From: [Jeff Levinsky](#)
To: [Council, City](#)
Subject: Proposed Height Transition Ordinance Needs Fixing
Date: Friday, April 8, 2022 10:40:13 AM
Attachments: [Height Transitions April 10 2022 Comments.pdf](#)

City of Palo Alto City Council Staff Report

Summary Title: Council Review of Changes to Height Transitions

Title: Public Hearing: Adoption of Ordinance Clarifying Ambiguities in Height Transitions, Adding RMD to the list of Residential Districts and Amending the Setback for the RM-40 Zone District

Figure 1: Height Transitions for Parcels Not Abutting (Leapfrog Scenario)

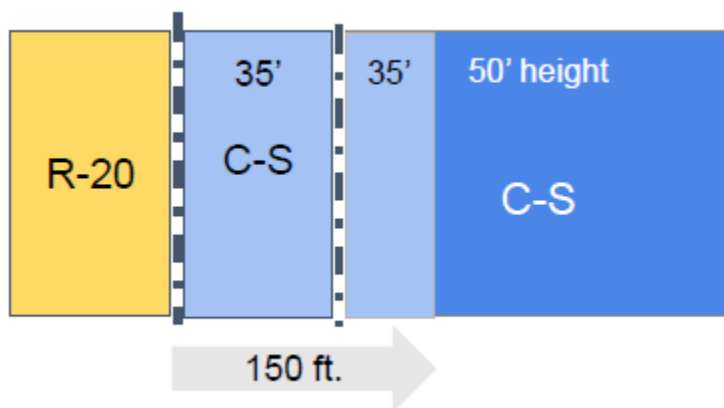
Actually, the proposed ordinance does not match Council intent to continue to allow “leapfrogging” where already in the code. See the ordinance below for examples and suggested corrections.
